Town of Parker Community Development Department  
Development Review Division  
Attention: **BrieAnna Simon**

Application Type: **Site Plan**  
Status: **First Referral**  
Application Name: Lot 1 Block 1 Horseshoe Ridge - Learning Experience SP  
Case/AP#: **SP19-061**  
Referral Received: June 19, 2019  
Comments Due: July 18, 2019

Review date: **July 12, 2019**  
Plan reviewer: **Randall L. Capra, [rcapra@parkeronline.org](mailto:rcapra@parkeronline.org)**  
Phone: 303.805.3169

**TOWN OF PARKER - FIRE/LIFE SAFETY:**

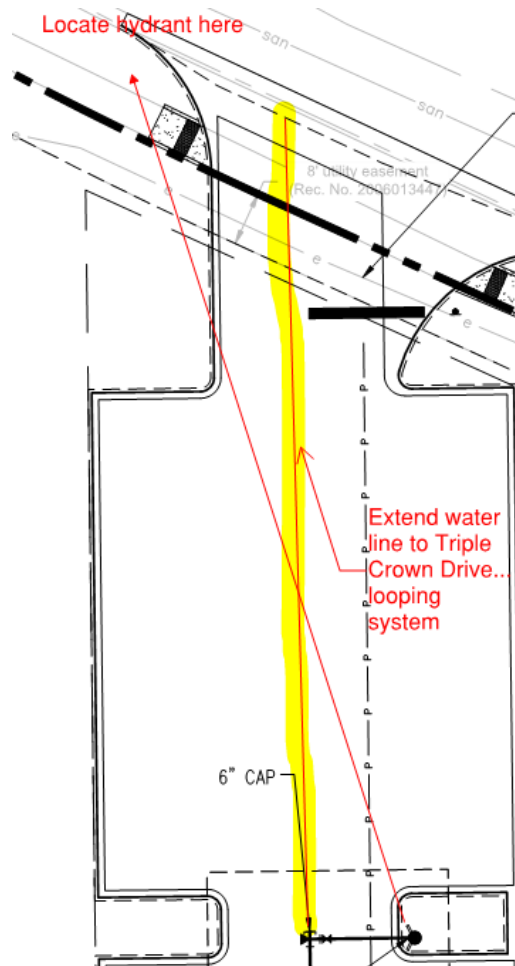
6. The applicant shall provide a fire hydrant at the n/w entrance to the site; this issue shall be addressed when resubmitting. *Not satisfied; applicant has not addressed with current submittal. Not satisfied; applicant has not addressed with current (THIRD) submittal. A fire hydrant has been provided at the NW entrance to the site. This Hydrant will be connected within Triple Crown Dr. The additional main along the West side of the building will no longer be used. The water main will loop within the southern TLE drive and the Northern Retail drive, both connection points in Pardee.*

7. *The applicant had indicated that the UFL and the fire hydrant are to share a dead end water main; the applicant shall revisit the submittal and place the fire hydrant on its own tap. The UFL and the fire hydrant are not allowed to share the same line. Not Satisfied; the water main, located on the south side of the building shall be looped/extended to Triple Crown Drive with the fire hydrant that was located on the n/w corner of the building, located at the n/w corner off of Triple Crown (see below). Address this issue when resubmitting. Fire hydrant has been moved and water main now loops through the South with both ends of the loop tying into Pardee Street*
